# MIDTOWN: PUBLIC SQUARE

PROJECT INFORMATION

2301 E Union St, Seattle WA

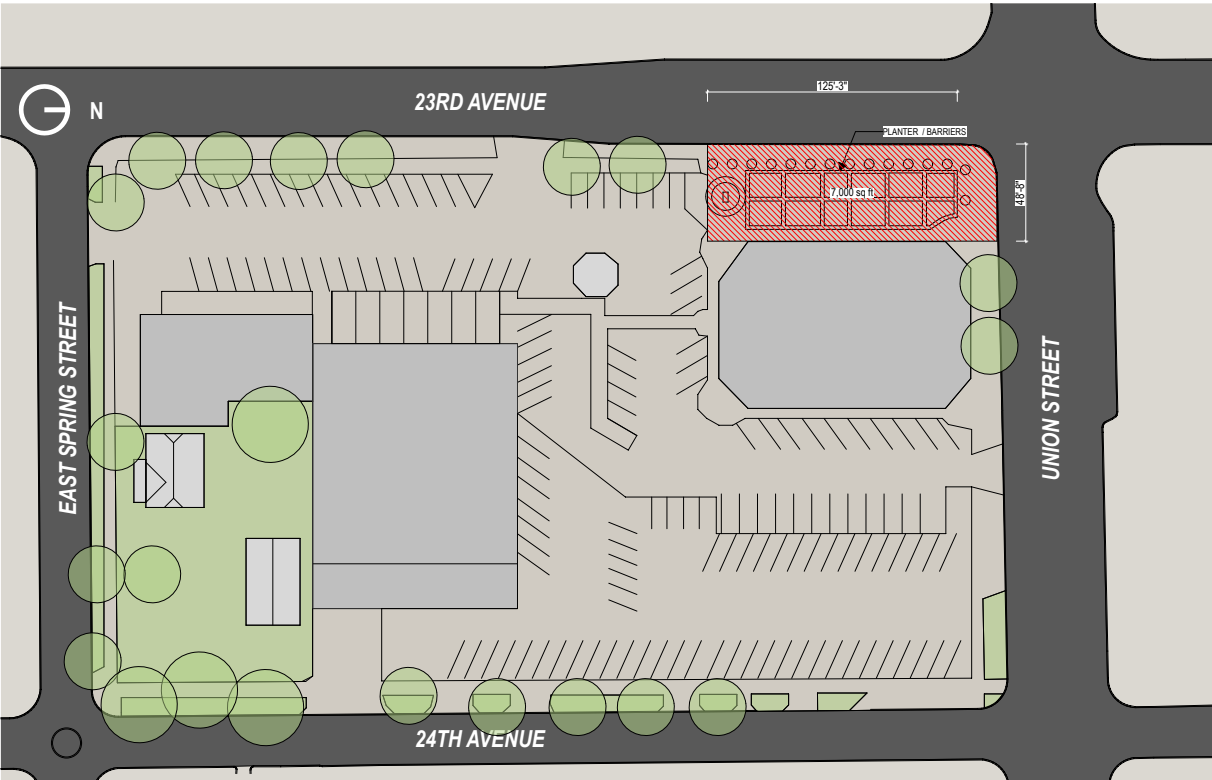
1a. At the EDG meeting the ground level setbacks at the corner of 23rd and E Union were treated with unique paving, flexible seating, planters and other street furniture, with the adjacent street-level façades fully- glazed with aluminum storefront windows possibly incorporating roll-up doors at key locations (EDG packet, p. 59). In the Recommendation drawings, the amount of glazing had been significantly reduced and a ‘digital art wall’ replaced the glazing at the north elevation facing E Union St. This digital installation was described by the applicant as intended to provide an opportunity to express neighborhood character and history through the illustration of a variety of images and videos.

1b. The Board was intrigued by this idea and asked many questions about the technology involved, the curation of images that would be shown, the tactile nature of the wall, and the way pedestrians might interact with it. The applicant explained that they were in the early stages of exploring this idea and many of these questions were still being resolved. A Board member noted a comparable street-edge condition (of which all were familiar) and agreed that the creation of a similar ‘dead zone’ or unusable space on the street should be avoided. The Board concluded they would need complete details to support the proposed video wall over a glazing system and its potential to encourage and engage human interaction.

**Response:** The corner plaza has been refined to offer more informal seating spaces, providing flexibility for both organized events and a series of informal gatherings. The space has plenty of permanent seating and gathering options, variety of plantings, and power and lighting for events. The programming of the space will allow for a range of community events, small markets, and dinners. This space will also have a significant art installation as part of the project’s art program and instead of the previously proposed media wall.

### 5. FOUNTAIN

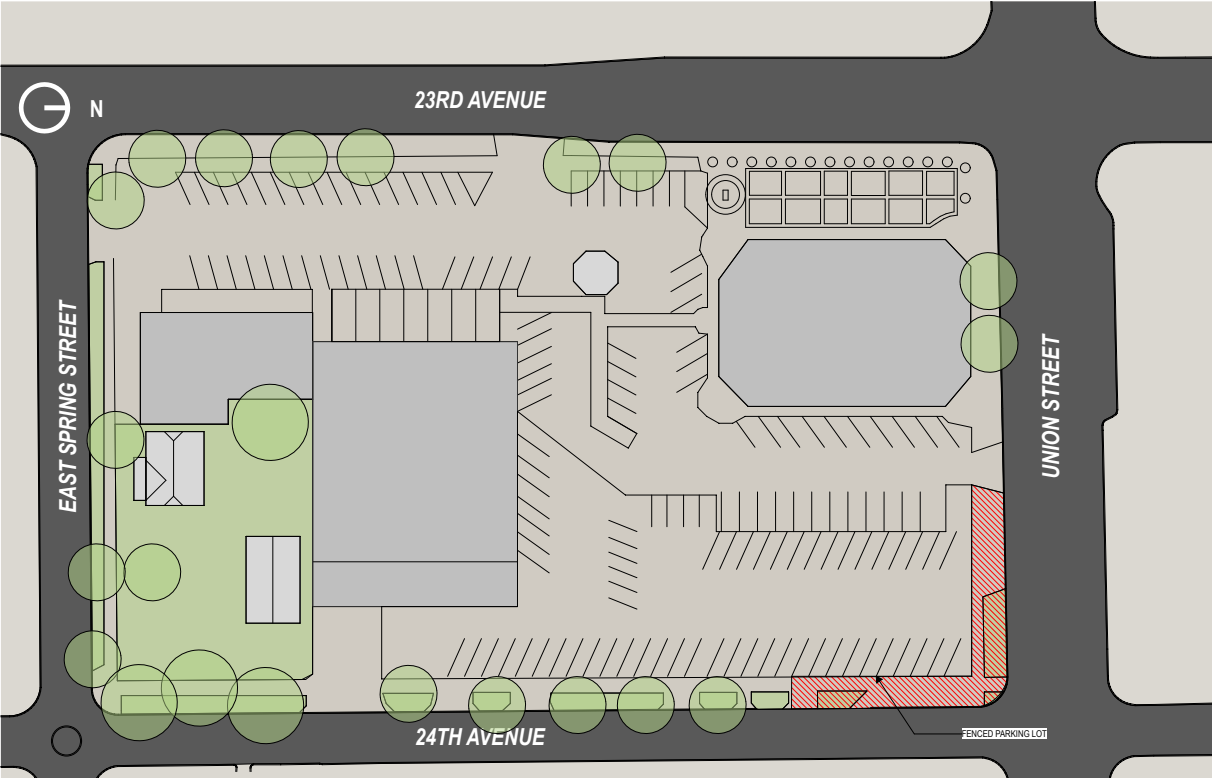
5a. The applicant presented a letter from the James Washington Fountain Foundation expressing support for the proposed location of the fountain at the corner of 24th Avenue and E Union St. The Board appreciated this endorsement but asked questions about the sufficiency of space around the proposed location at this corner and were concerned about its proximity to the trash, loading, and garage entrance, and potential conflicts between users (particularly children) and vehicles.

5b. Having heard during the public comment period the importance of this statue and the significant dimension of the water feature it was originally installed with, the Board requested complete details describing the fountain and an exploration of the positive and negative impacts of other potential locations.

**Response:** The fountain has been located closer to the property line towards E Union St in order to create a more prominent visual connection. The fountain is separated from the driveway by a large planter that includes significant density of trees and shrubs to provide a visual screen between the loading area and the plaza. The fountain will also be surrounded by outdoor seating and additional plantings as part of the adjacent retail space.

**Response:** This location gives the fountain the prominence that it deserves while providing a contemplative space to enjoy it. There is opportunity for additional artwork by the artist in this area, as well as art inspired by the artist. This corner also provides a great connection to another important places in the Central District - particularly the Liberty Bank project across E Union St. By working with the neighborhood, SDOT, and the developers of the Liberty Bank project, we are hoping to turn this intersection into a celebration of some of the pioneers in the CD. 'The Fountain of Triumph' was originally designed for community gathering and to reflect unity for the Central Area neighborhood.

### 2. PORTAL ENTRANCES

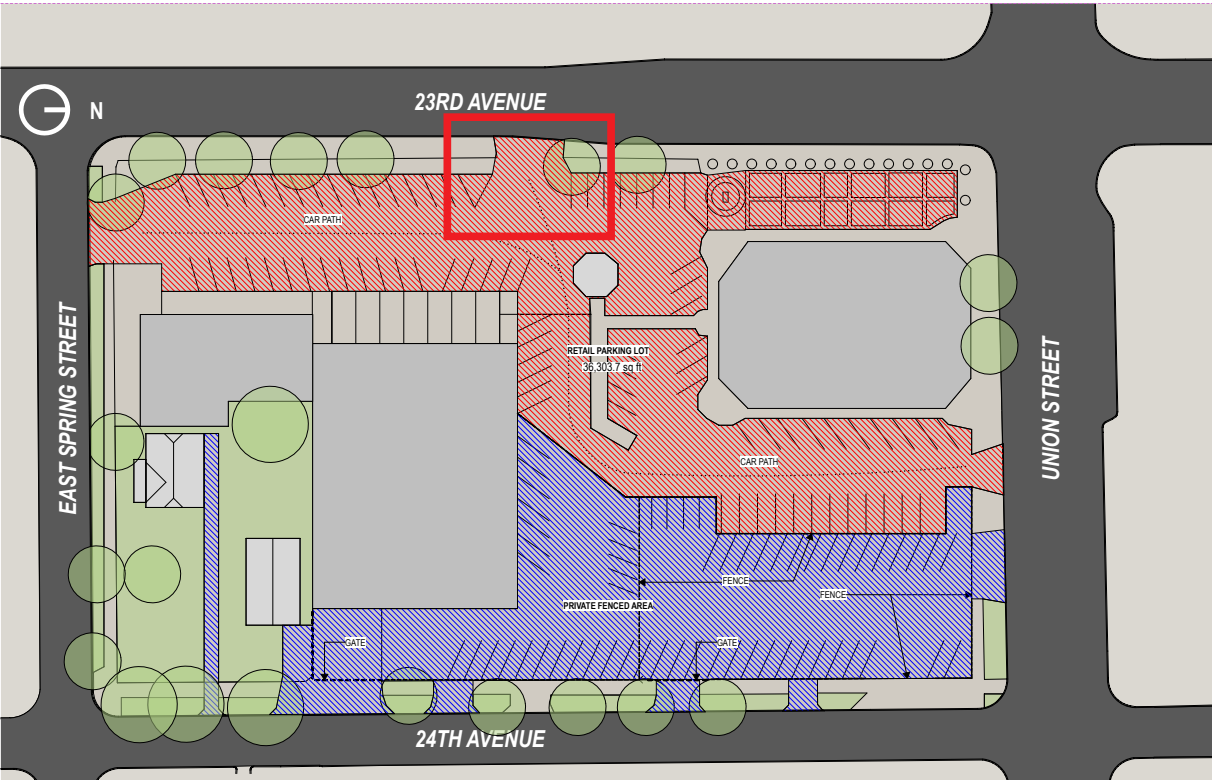
2a. At the EDG meeting, the Board the expressed concern about the design and width of the portals and asked the applicant to revisit and revise their design. The applicant's response included: moving the southwest/southeast portion of the building to slightly (no dimensions were shown or provided) increase the size of the portals on 23rd and 24th Avenues, but not at the key gateway corner location on Union; shifting the walls at the northwest portal to decrease its depth; and using transparency at corner retail spaces along the portals. The applicant also noted the high level of transparency at the pedestrian bridges above each portal as mitigating their impact

2b. The Board appreciated these changes but agreed the portals did not yet feel welcoming, make the 'open to the public' nature of the courtyard clear, or yet have an effective design strategy to draw the public in. The activation of this space was identified by the applicant, the public, and the Board as critical to the success of the courtyard area, which has been the central organizing principal for this project from the beginning. The Board echoed public comment in their support for the applicant's intent to accomplish this and asked for continued development of the design.

**Response:** The bridges above the 23rd Ave and 24th Ave portals have been removed, further emphasizing the openness of the portals as they lead into the Square. Each of the portals have also been widened by 5-0 feet. The portal on Union is still the largest, and the bridge above is planned to be treated with artist vision of a welcoming "arch".

**Response:** The portals will be emphasized by a break in the façade and further characterized by different paving, lighting, Signage, furniture, vegetation, and storefronts that turn the corner and lead into the Square.

### 2. PORTAL ENTRANCES

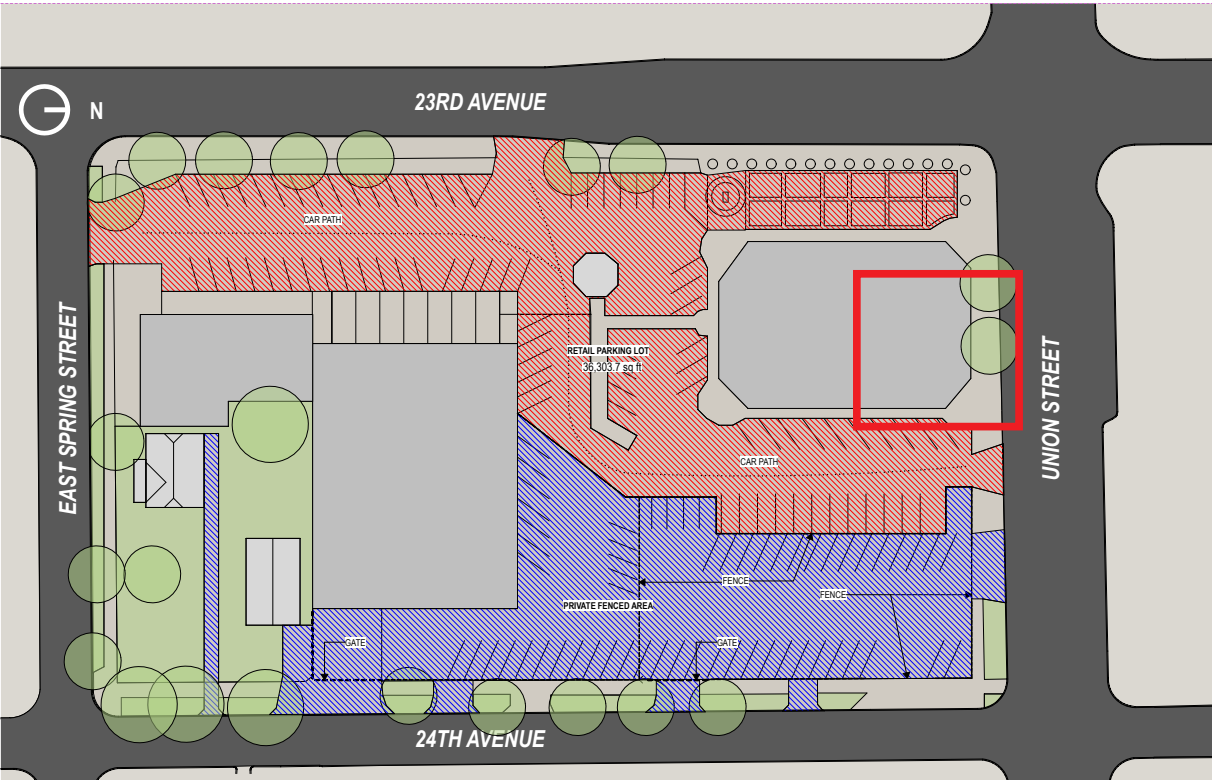
2c. The width of the portals (approximately 18-feet) was a specific concern of the Board at EDG. The Board appreciated the increase in width of the portals on 23rd and 24th Avenues but was disappointed that what they saw as the most important portal (at E Union St) had changed so little. They agreed that the ‘shift’ making the passage less deep was positive but would like to see more significant change in response to their guidance.

**Response:** Each of the portals have been widened by 5-0 feet. The Union portal is the largest one; and including the corner plaza, it is the shortest one to the Square. Based on the Community Outreach, all portals will also have public art opportunities to further welcome the neighborhood. See the Art diagrams for the locations and size of the art proposed. The Art RFQ process is in development, but we are looking for neighborhood based artists. All the portals will have catenary lighting or other artistic lighting installations to provide an inviting atmosphere. All the portals will also have a variety of plantings and types of seating to further welcome the public.

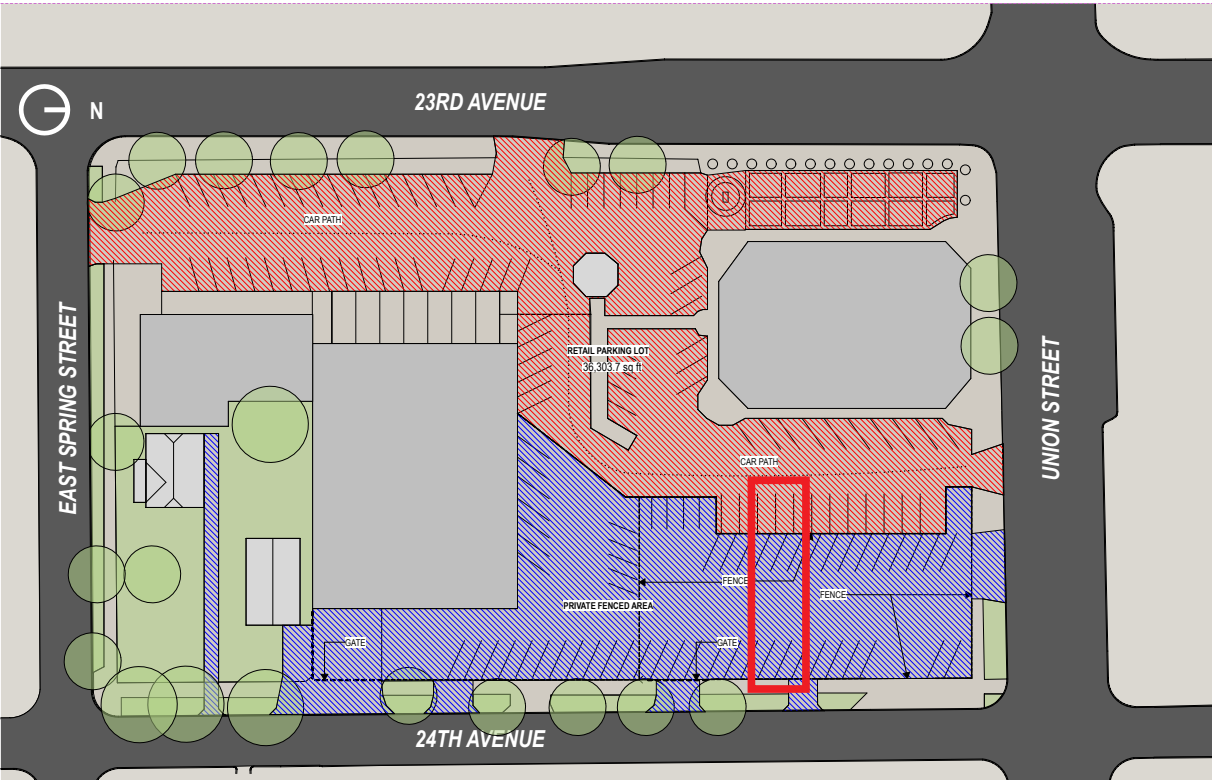
6d. The Board also noted that if not well-designed, a narrower curb cut could result in delivery trucks parking on the sidewalk, blocking the flow for pedestrians. The Board also suggested that significant landscaping and hardscape variety could mitigate potential use conflicts at this location.

6e. The Board concluded that they lacked adequate information and detail at this time to clearly understand the condition, particularly how the various uses could be accommodated without conflict, and how it will better meet the intent of the design guidelines than a code-compliant solution.

6f. For the next meeting, the Board requested a complete exploration of possible solutions, including the possibility of using below-grade space to lower 'demand' for curb-cut width. Thorough documentation and detail of the proposed solution will be needed for the Board to understand. A code-compliant option should also be included as that is required in all Design Review processes.

**Response:** The proposed 60-0 ft curb cut would mitigate any risk of trucks parking on and blocking the sidewalk.

**Response:** A code-compliant option would include multiple driveways spaced throughout the site, causing more pedestrian interference and multiplying possible vehicular/pedestrian conflict areas. We have provided a plan showing the code compliant option - we are allowed up to 13 curbcuts on all three frontages. Due to the designation of 23rd and East Union there are no curbcuts allowed on those streets, which means only 24th can have any curb cuts. The length of 24th allows for up to (6) curbcuts that are up to 22-0 wide for a total of 132-0 (length of project on 24th is 420-0 feet, per table A for 23.54.030). We would prefer to limit the car/truck access as close as possible to the commercial area along East Union and therefore are asking for a single, larger curb cut to contain all the vehicular access needs.

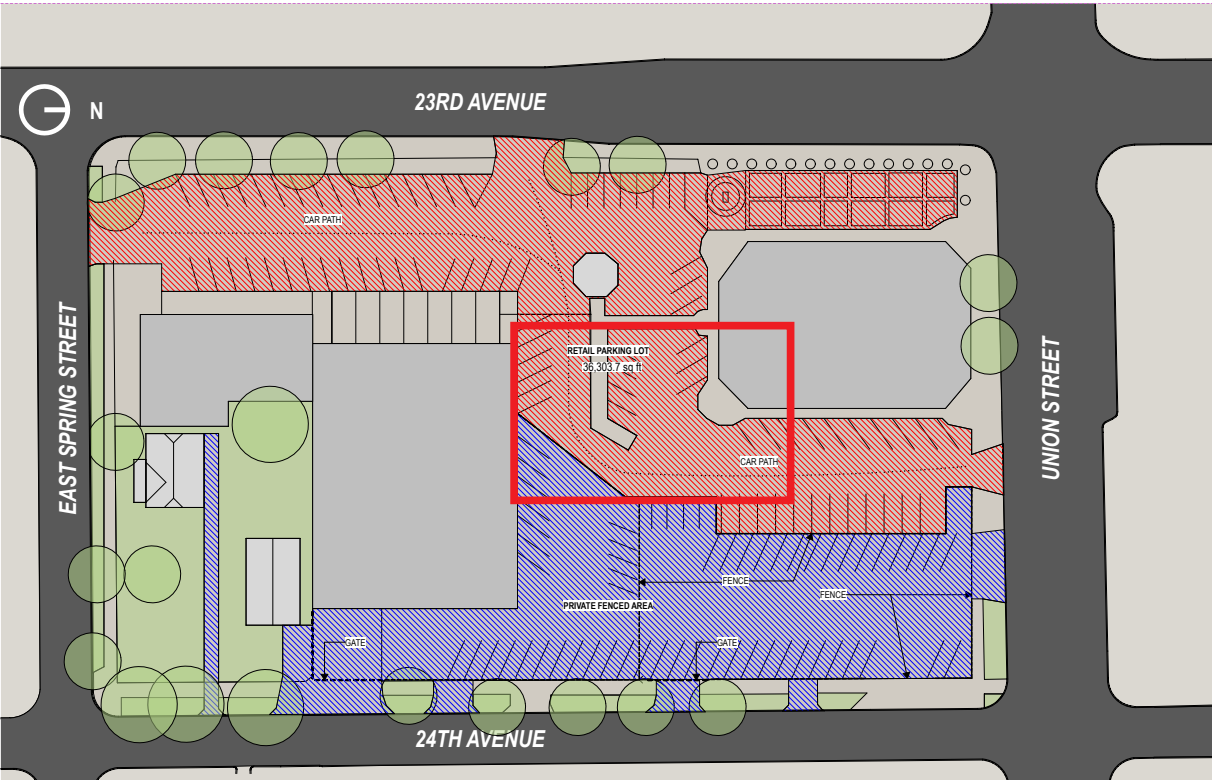
3a. At the EDG meeting, the Board and applicant heard public comment that recommended looking outside western and euro-centric norms of rectilinearity in the design of the courtyard and the incorporation of more diverse and Afrocentric design sensibilities and principles. At that meeting, the Board agreed that the courtyard design needed refinement and identified the community’s suggestions as a possible solution.

3b. In the response to this EDG guidance, the applicant refined the courtyard design to include elements of wood decking at grade, raised concrete planters, a stage, and a variety of landscaping and hardscaping materials. The patterns and textures were described as reflecting the ‘global grid’ concept from the Recommendation packet (p. 42-43) and the existing neighborhood cultural context by using balanced asymmetry, abstract form and symbolism, and modern pattern organization. The Board agreed that the forms generated from these concepts could be successful but were not clear on the connection to community input, echoing public comment that a ‘loop back’ with the community would be a positive process step in informing next design steps.

3c. A pattern overlay of wood decking at grade was proposed at the perimeter of the courtyard, close to the buildings and then elevated at the west for a proposed ‘stage’ area. The Board expressed concern regarding the durability of this material, and its tendency to become slippery when not protected from the weather, and questioned the location of the stage area, suggesting an exploration of a central location, which would provide sitting places on all sides.

3d. There was significant public comment at the Recommendation meeting expressing disappointment that this design did not respond to feedback offered at previous outreach meetings and at the Africatown Design Ciphers. Two alternate site plans were offered during the comment period by a Cipher attendant and found in the Recommendation packet (p. 70) labeled “Africatown’s Preferred Options” that showed more generous setbacks at the portal entries, creating larger shared open spaces. Acknowledging these public comments in their deliberation, the Board agreed that enlarging these spaces could be a positive move, particularly as it would have the potential to indicate the courtyard beyond and draw people through to this space.

**Response:** While the shape of the Public Square has remained rectilinear because of the building edges, the spaces within the Square are shaped by curved, wooden decks/platforms and vegetation to create areas of circulation and gathering.

**Response:** The Central Square has been refined to offer more informal seating spaces, providing flexibility for both large events and a series of smaller gatherings. The space has plenty of permanent seating and gathering options, variety of plantings, and power and lighting for events. The programming of the space will allow for a variety of community events: farmers markets, dinners, concerts, and/or movie nights. The space will also have movable furniture and play equipment, allowing for informal gatherings throughout the day. The planting will include a variety of Pacific Northwest plants, some being edible.

**Response:** The wood decking in the Square will be specified to meet requirements for high traffic exterior environments. The stage was placed on one edge of the Square to create a directional focal point for spectators and to allow a central location for a prominent tree. See the plans indicating the amount of linear feet of built-in seating that will be provided at the Square.

**Response:** In the packet, there is a series of diagrams showing the desired changes that were suggested at the Cipher and the current design. The project has incorporated several of the desired changes suggested at the Cipher, including setting back at the corner of 23rd and Union to create a plaza, opening up the retail along the 23rd portal to increase the width, and removal of the overhead bridges at the 23rd and 24th portals. All of these moves were intended to creating a more welcoming streetscape and better connect that streetscape with the Public Square.
